Roundup Power Project

Final Environmental Impact Statement

January 2003

Figure 3-7

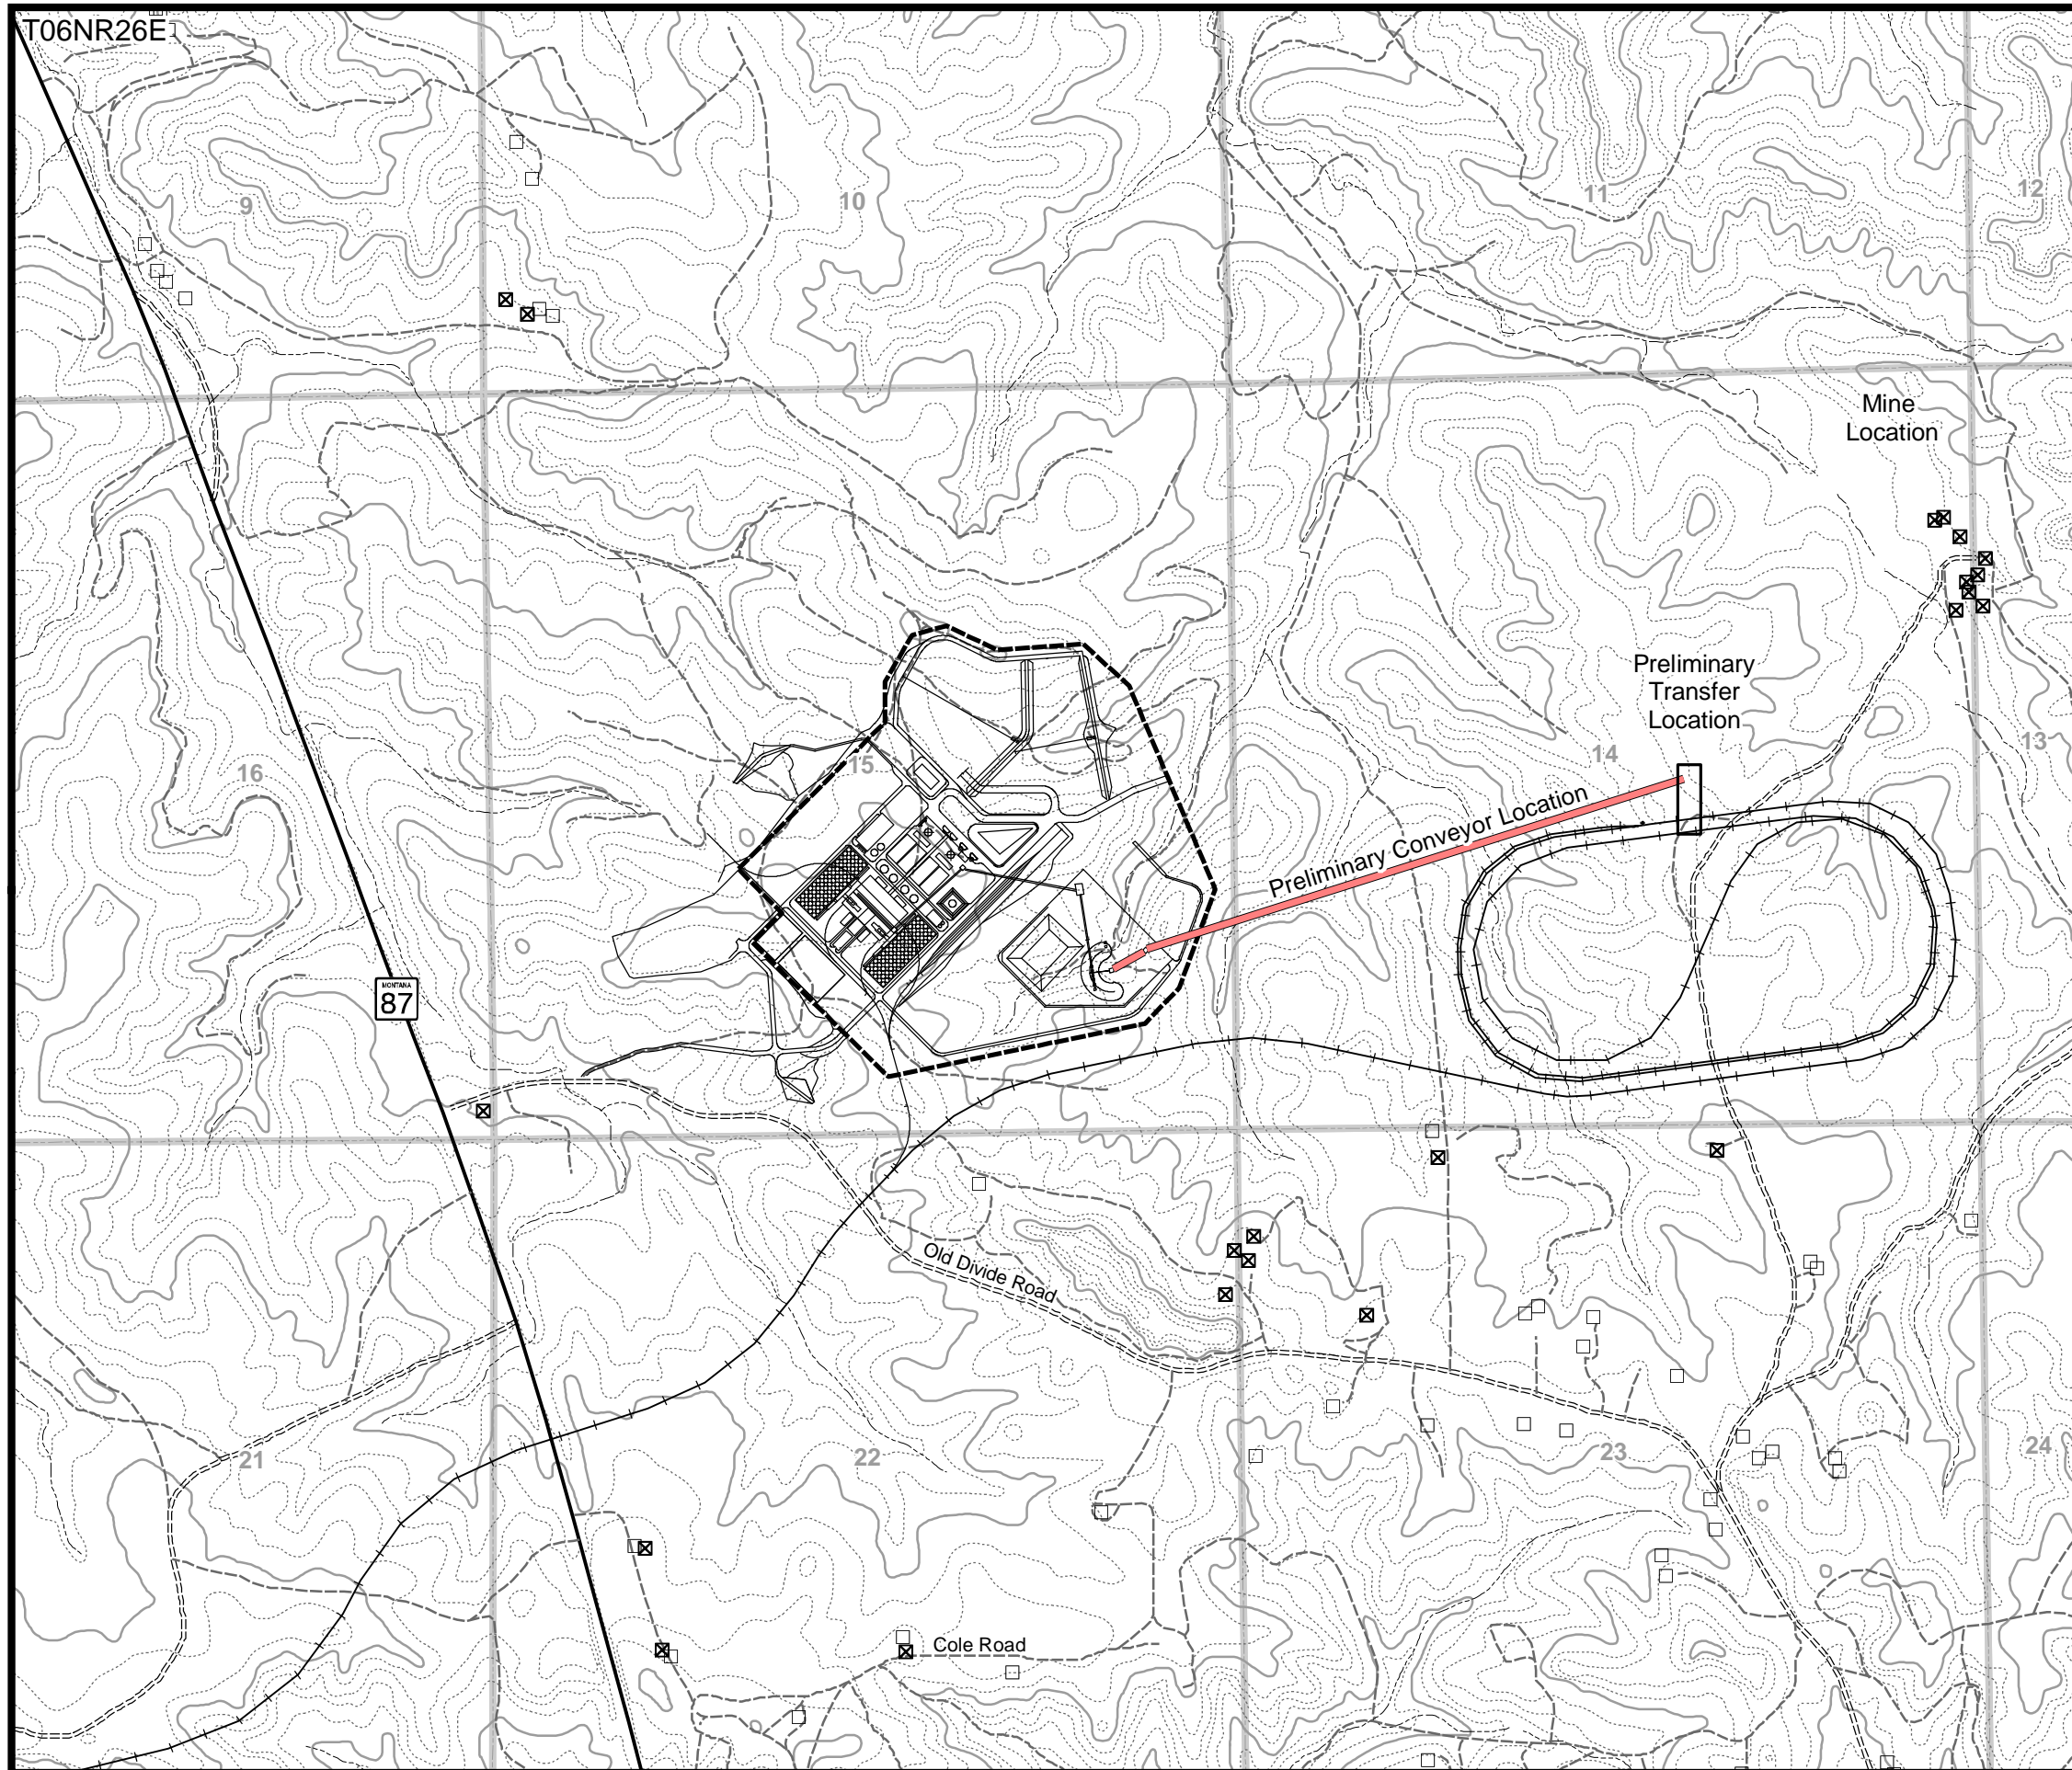
Page 3-55, Figure 3-7 Land Use, add label for Cole Road. See attached map at the end of this section.
